SUBJECT: VERMONT YANKEE NUCLEAR POWER STATION - ISSUANCE OF
AMENDMENT RE: ENHANCEMENTS TO SUPPORT INCREASED CORE
FLOW (TAC NO. MA6152)

Amendment No. 187
License No. DPR-28

SAFETY EVALUATION BY THE OFFICE OF NUCLEAR REACTOR REGULATION

RELATED TO AMENDMENT NO.187 TO FACILITY OPERATING LICENSE NO. DPR-28

FIGURE 2.1-1

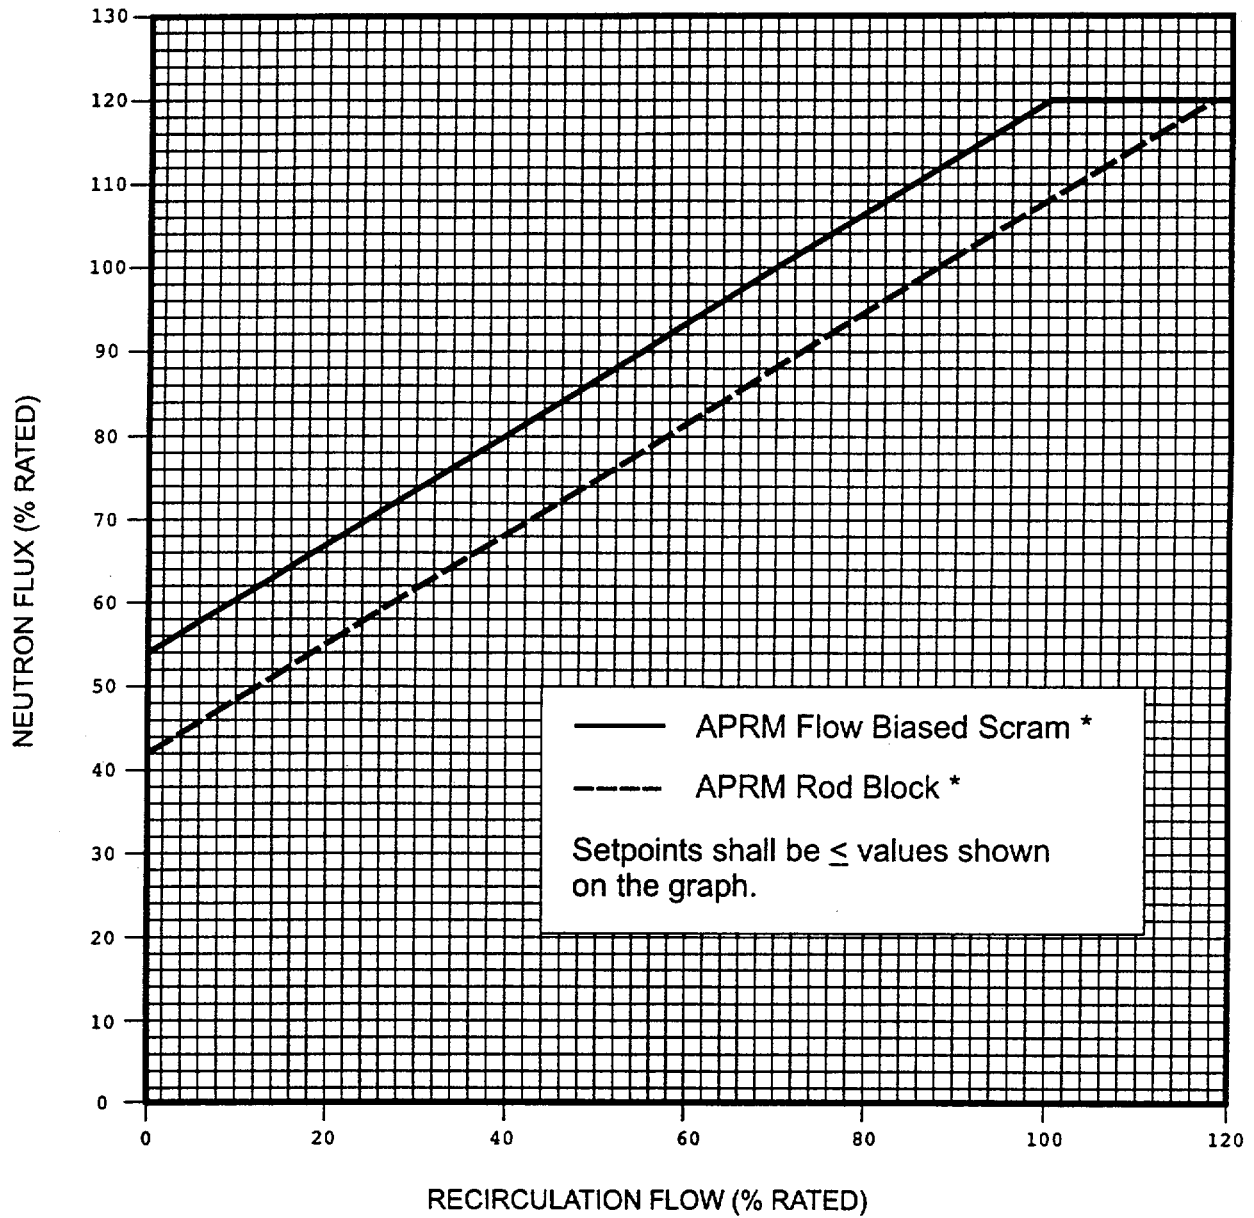
A. Addition of Clarifying Statement in Figure 2.1-1

In Figure 2.1-1, "APRM Reference Scram and APRM Rod Block Settings," the licensee proposed adding the statement "Setpoints shall be \leq values shown on the graph." TS Section 2.1 states that the "settings shall be as shown on graph 2.1.1" and the licensee indicated that the statement could be interpreted to mean that the trip setting should be strictly the values specified for the flow-biased APRM scram and the APRM rod block plot. However, the plot is just a graphical representation of the flow biased APRM scram and rod block equations and the settings are required to be less than or equal to the value represented on the plot.

The APRM flow biased scram and rod block trip settings are specified by the linear equation specified in section 3.B of this evaluation and figure 2.1-1 is only a plot of the trip setpoint equations. The staff finds the proposed change to be acceptable because the plot is a graphical representation of the flow biased APRM scram and rod block equations and the settings are required to be less than or equal to the value represented on the plot.
